**BLOOMINGTON PLAN COMMISSION
STAFF REPORT**

**CASE #: SP-23-19
DATE: July 8, 2019**

**Location: 222 S. Walnut Street
105 & 111 W. 4th Street**

REQUEST: The petitioner is requesting site plan approval for a new parking garage in the Commercial Downtown zoning district.

4.) GREEN ALLEY

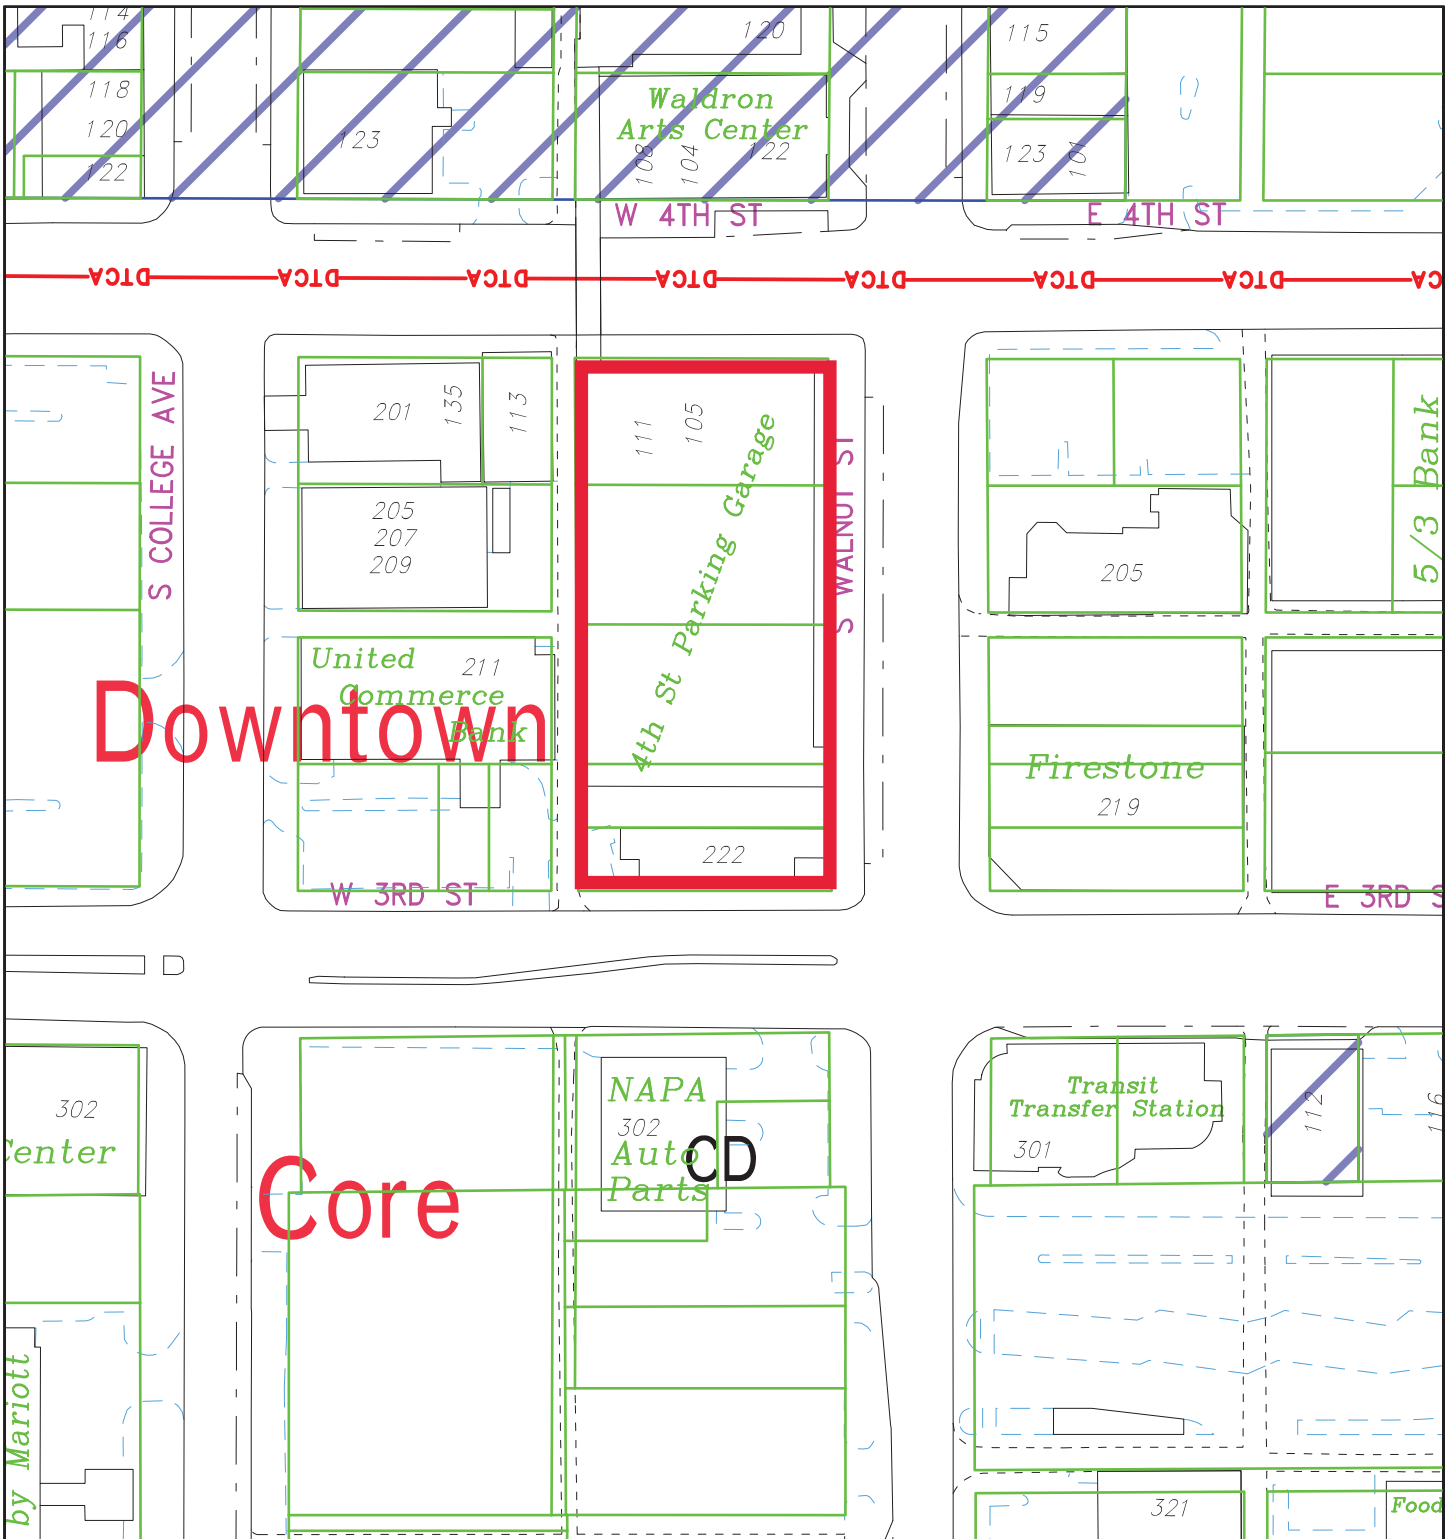
The EC recommends that the alley behind the parking garage be reconstructed using “green alley” techniques. The alley will no doubt be destroyed during construction and will have to be rebuilt anyway, so that makes it a good candidate for a green infrastructure best practice, called a green alley. The City of Chicago made this practice commonplace and published the Green Alley Handbook <https://www.chicago.gov/dam/city/depts/cdot/GreenAlleyHandbook.pdf> to help other municipalities. Although it is narrow, this alley could benefit from some of the practices outlined in the handbook. Some pedestrian-friendly amenities, such as lighting on the sides of the building, landscaping, and functioning pervious pavement could convert this eyesore space into an inviting multi modal way.

7. The petitioner will submit a plan for pedestrian improvements to the alley east of the site, while working in conjunction with adjacent property owners and tenants.

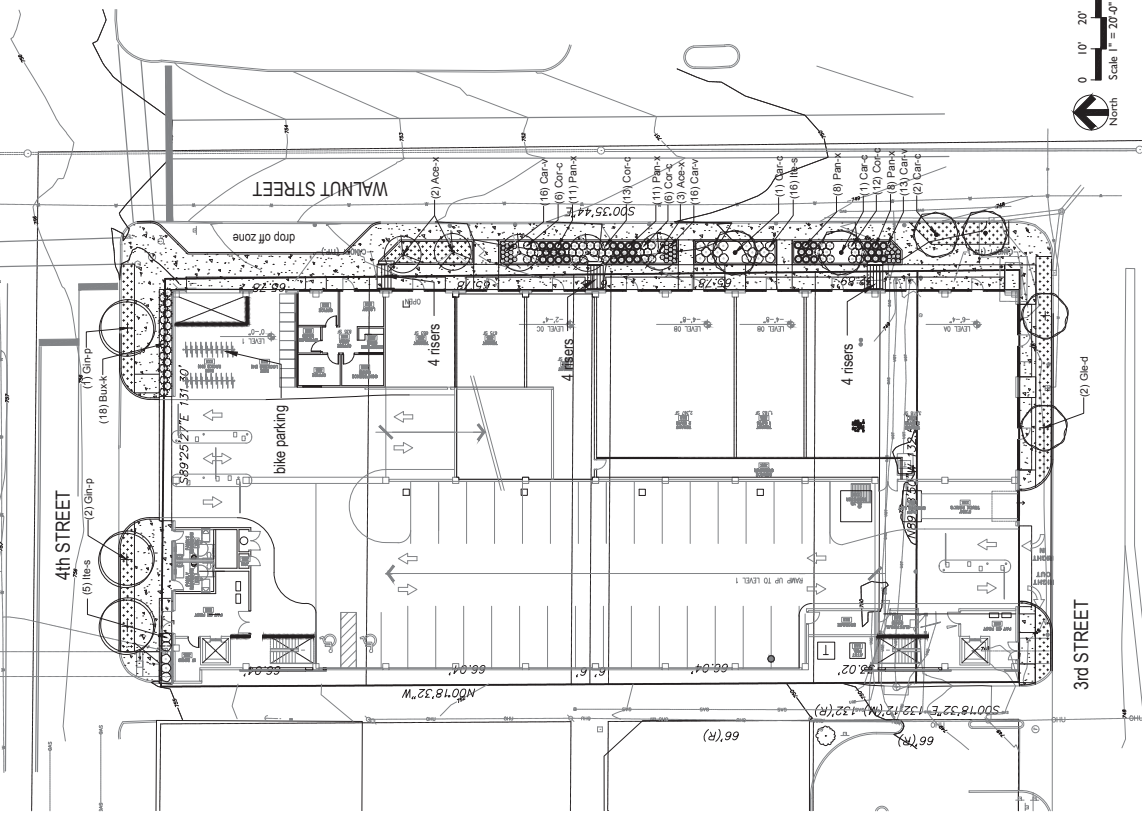
Streetscape: Street trees and pedestrian-scaled lighting are required along 4th Street, 3rd Street, and Walnut Street. The current iteration of the site plan does not show plantings/trees in the tree plot along Walnut Street. The Department has spoken with the petitioner about correcting this design. The total number of street trees for the site should be 1 tree per 40 feet of frontage, not excluding vehicular drive cuts. This site requires the incorporation of 14 street trees with separation ranging from 20 to 40 feet on center. The petitioner is seeking incorporation of bioretention in the tree plot area along Walnut Street. To that end, there may be a small reduction in the number of street trees, if alternative plantings are approved in their place. Street tree requirements are

Because this site falls within the Commercial Downtown Zoning District and the Downtown Core Overlay District, there are few landscaping requirements; nevertheless, the plan is currently not compliant with Unified Development Ordinance (UDO) requirements. The EC recommends that the Petitioner work with the Senior Environmental Planner to bring the plan into compliance.

5. Required bicycle parking for the commercial spaces will be added to the site plan before a grading permit is approved.
6. The petitioner will submit a site plan that meets the minimum street tree requirement. If the petitioner desires to use a portion of the tree plot area for bioretention to serve the site, the Senior Environmental Planner must review such a plan and approve any reduction in street trees.

Exterior Elevations

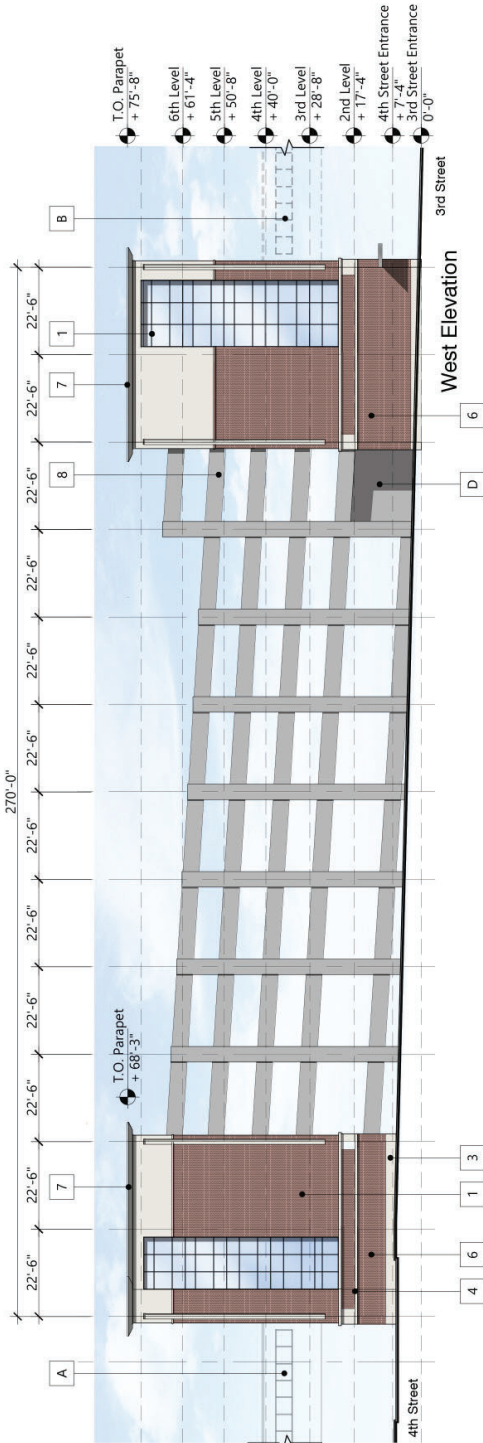
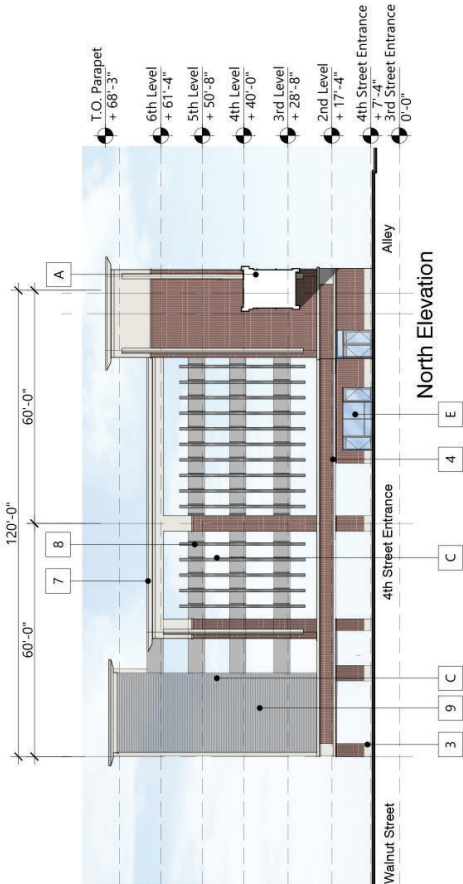
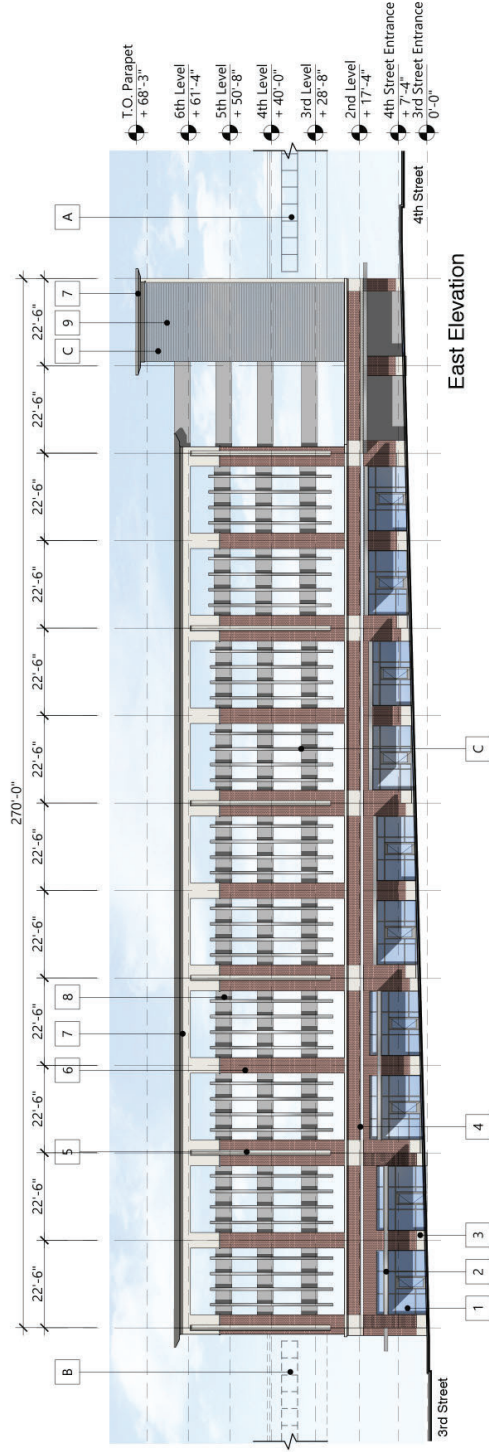
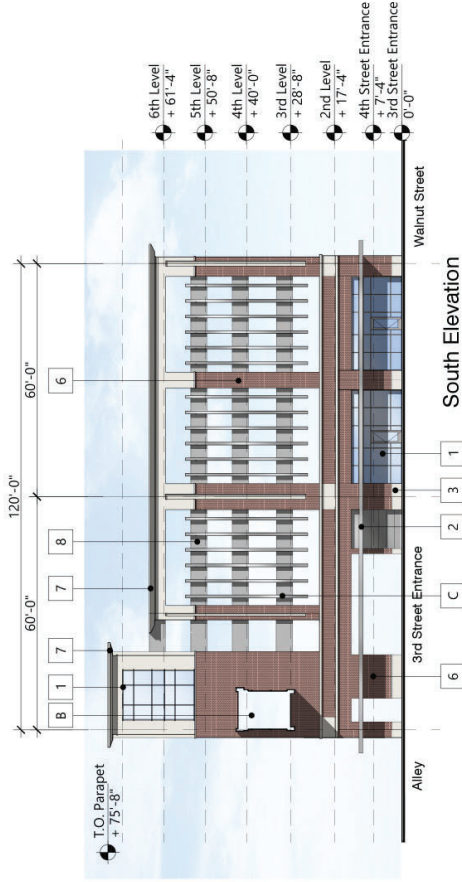
The primary material to be used on the majority of the garage is brick. There will be accents included that will be limestone at the pedestrian level (first floor and header above) and 'cast-in-place' concrete accents above. The UDO does not allow cement block in the DCO. The petition does not meet materials requirements (use of cast-in-place concrete). While much of this will be concealed by the large vertical louvers, the last module of the garage is open at the north end of the garage on Walnut Street, making the concrete levels quite visible. The Department prefers that that portion be treated in some way.

BMC 20.03.130(c)(1) requires a maximum façade width for each module of 65 feet for those sides of the buildings with frontage and a minimum façade width of 25 feet. The offset is to be a minimum of five percent of the total façade length, extending the length and height of its module. This requirement is included to provide visual interest in new development and discourage large monolithic buildings. The parking garage use makes meeting this requirement difficult, as the space needed for parking spaces and drive aisles is standard and cannot easily be varied. The petition does not meet this requirement.

BMC 20.03.130(c)(3) requires that building facades over 45 feet in height shall step back the horizontal façade/wall plane a minimum of 15 feet from the horizontal façade/wall plane below 45 feet in height and above 45 feet in height. Again, the parking garage use makes meeting this requirement very difficult, as the spaces and aisles have standard lengths that need to be met. The petition does not meet this requirement.

The DCO sets a minimum first floor void-to-solid requirement of 60%, consisting of transparent glass or façade openings, for facades facing a street. Upper stories are required to have a minimum of 20% void area. The DCO also requires a height-to-width ratio of 1.5:1 for upper story windows and the incorporation of lintels and sills. Because the parking garage is being designed with open air facades to facilitate increased natural light and air circulation, the design of the structure does not support these more traditional building design requirements. The petition does not meet these requirements.

The EC is disappointed that the design does not contain any of the local limestone that this region is

famous for. Using concrete that is limestone colored is not an acceptable replacement. We recommend that all proposed masonry headers, accent courses, and cornice details be crafted from local limestone instead of concrete.

8. The petitioner will amend the elevations of the northernmost module of the Walnut Street façade to treat or cover the exposed concrete elevations.
